HOSHIZAKI AMERICA, INC.

SERVICE BULLETIN

SB15-0006

SUBJECT: Mechanical bin Control on Stackable KM's

Single unit installation:

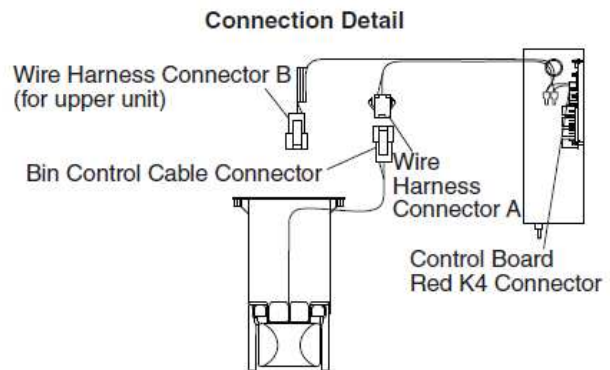
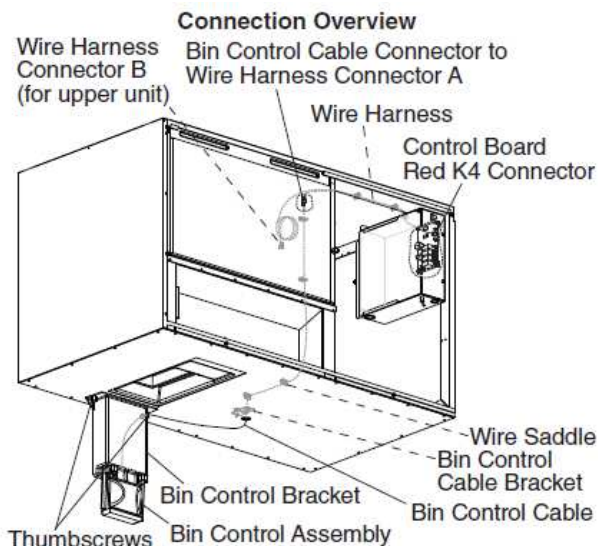
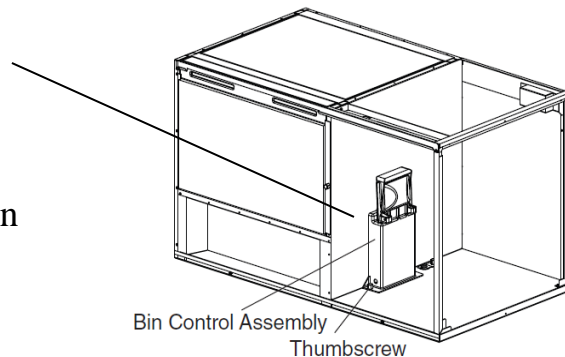
The mechanical bin control assembly will be shipped in the unit as shown here.

For a single unit, the assembly must be removed from inside the unit, mounted under the unit and connected at installation for proper operation as shown below.

Stacked unit installation:

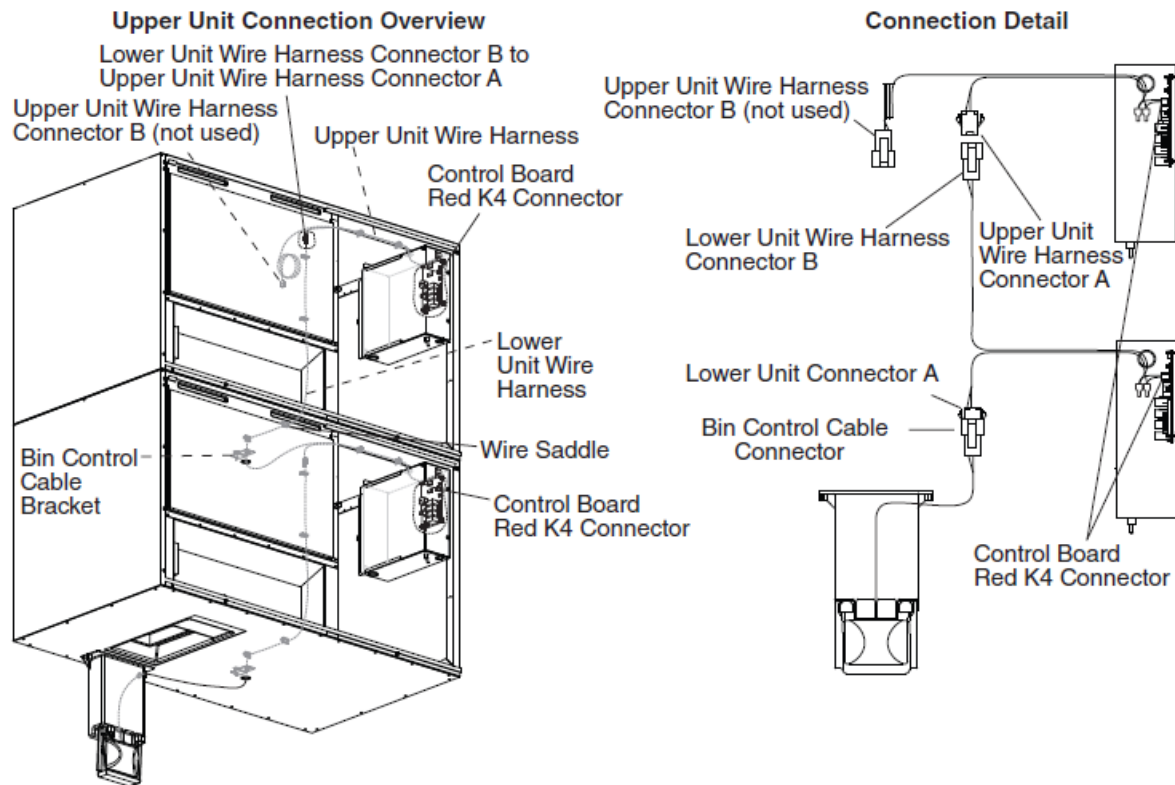
When 2 units are stacked, a single bin control is needed to operate both units. The necessary wiring harness is included to make this connection. See the illustration below for connecting 2 stacked units.

In this configuration, both units will operate simultaneously with the single bin control.
